**NSLPP MEETING HELD ON 05/02/2025**

**ADDRESS/WARD:** 34 Euroka Street, Waverton 2060 (E)

**APPLICATION No:** 288/24

**PROPOSAL:** Alterations and additions to a heritage-listed dwelling

**Figure 31: View from No.36 Eureka to subject site. Red Arrow on subject site depicts area of extension inclusive of first-floor deck**

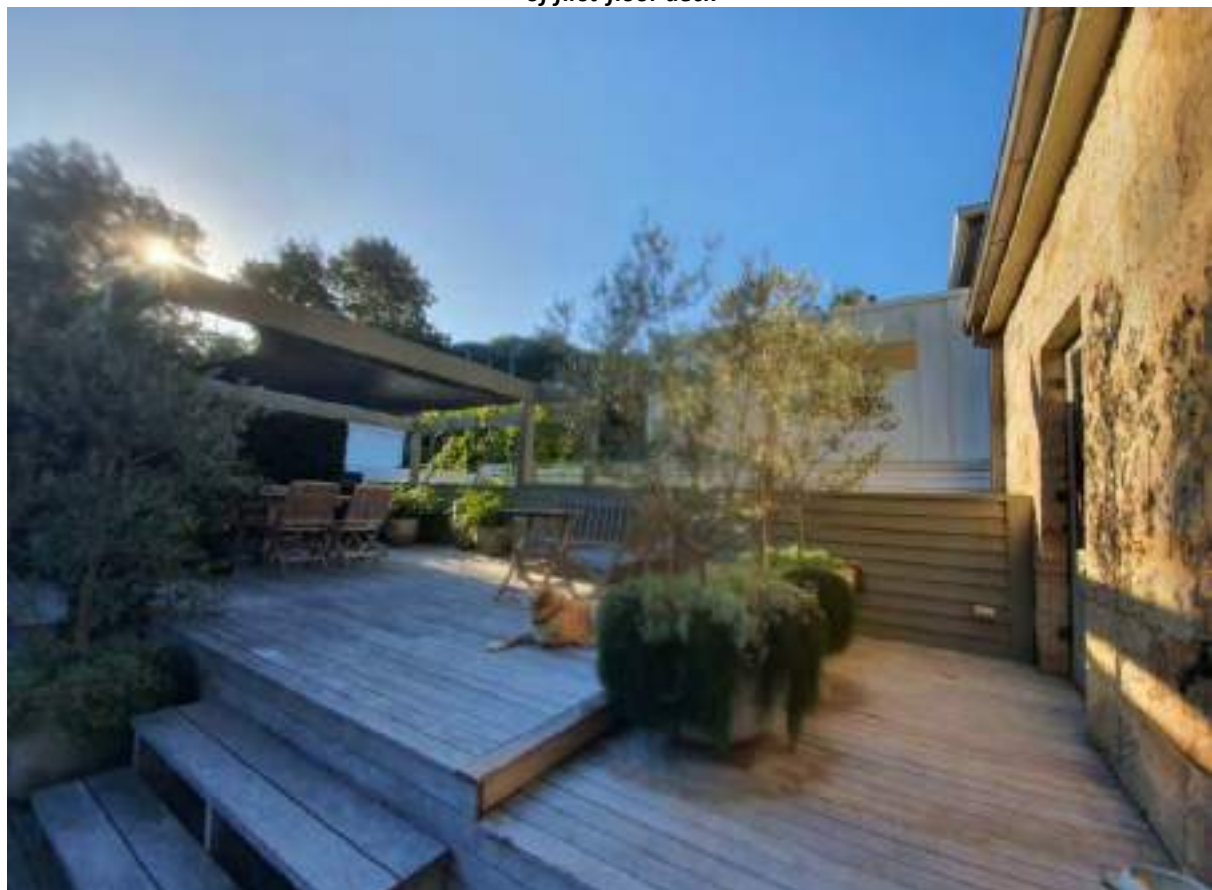
<b>1.3.6 Views</b>	Yes	<p>The Area Character Statement discusses significant elements as including slot views over and between buildings throughout the locality. The staircase structure is measured to be 5.4-5.9m in height measured from the front boundary natural ground line. The proposal does not contravene this as the site still allows slot views over the proposed staircase structure on the side boundary, not dissimilar to the approval for infill additions to side boundary of No.26 and No.50 Euroka Street.</p>  <p><i>Figure 29: Calculation for height as seen from streetscape</i></p> <p>The proposed dwelling and dwellings in vicinity maintain an outlook to trees and sky. The proposed addition allows for views towards Berry’s Bay for properties to the north which have an existing elevated topography. The adjoining property to the north at No.36 Euroka Street contains an outdoor sundeck at RL40.26 with a timber pergola structure to the rear. The first-storey of the subject site has a FFL37.67. The height difference between the sundeck at 36</p>

<p>Eureka Street and the subject site First Floor level is 2.59m. The sundeck on No.36 Eureka Street extends almost to the rear of their boundary and it is considered that an adequate view to Berry's Bay may still be obtained by 36 Eureka Street.</p> <p>The four step assessment in the planning principle <i>Tenacity Consulting v Warringah Council [2004] NSWLEC 140</i> is required to be considered to assess view sharing.</p> <ol style="list-style-type: none"> <li><b>1. Type of views affected?</b> Land view to a portion of the Anzac Bridge during the day and potentially at night.</li> <li><b>2. What part/s of the property at 36 Eureka Street are the views obtained?</b> The views are visible in a standing position from the rear deck southern boundary (side boundary).</li> <li><b>3. Extent of the impact?</b> The extent of the impact is considered to be moderate as views to the cityscape is still visible through the proposal. See <b>Figures 31 and 36</b> below.</li> <li><b>4. Reasonableness of the proposal</b> Tenacity states that the protection of views across side boundaries is more difficult, and the expectation to retain side views and sitting views are often unrealistic. No.36 Eureka Street has views to part of the Anzac Bridge via their southern (side) boundary.</li> </ol> <p>The existing views to the city buildings and Anzac Bridge are limited due to numerous mature trees located on properties south of No.36 Eureka Street. Furthermore, the view is obtained from the side boundary and Tenacity states that it is difficult to protect views from the side boundary. The proposal is deemed to be justified in this regard.</p>

**Figure 36: View from rear sun deck of No.36 Eureka Street to rear of subject site**

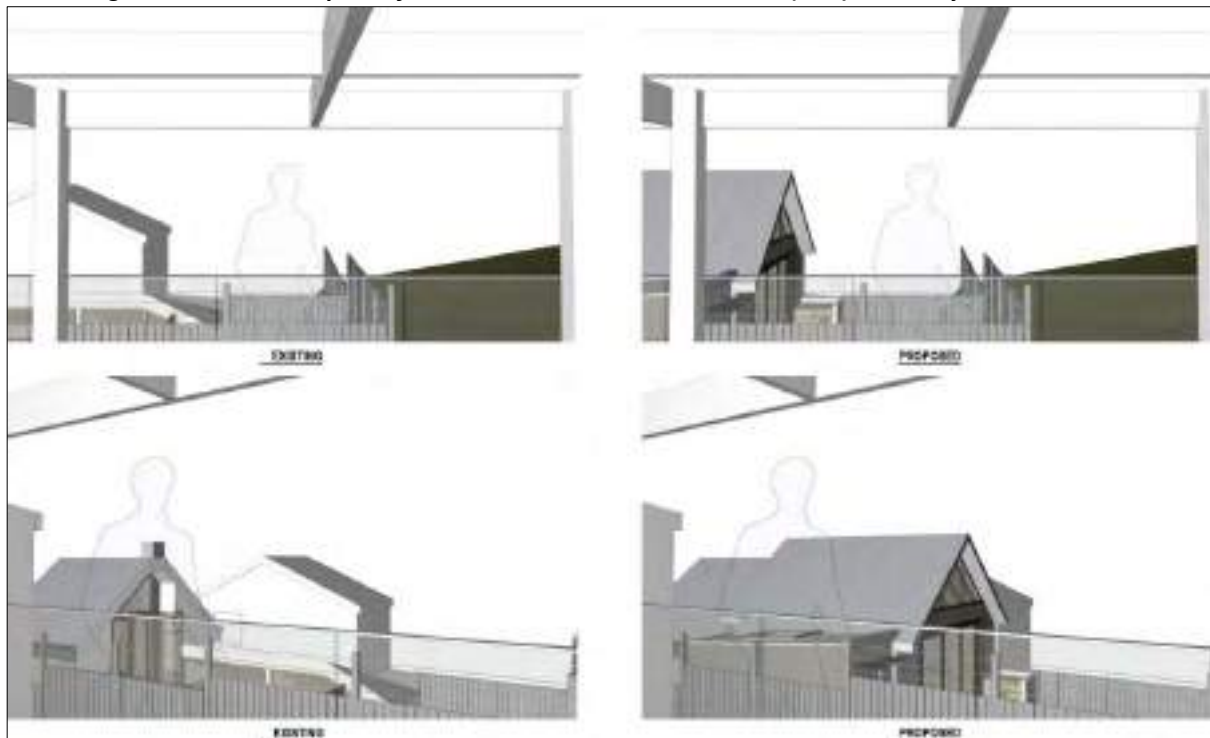
**Comment:** As per the planning principle resulting from the L&E Court case on view assessment *Tenacity Consulting v Warringah Council [2004] NSWLEC 140*, views from side boundaries are difficult to retain. There are also mature trees south of 36 Euroka Street along the rear of other properties that have already obstructed the bulk of the views to the cityscape/Anzac Bridge.
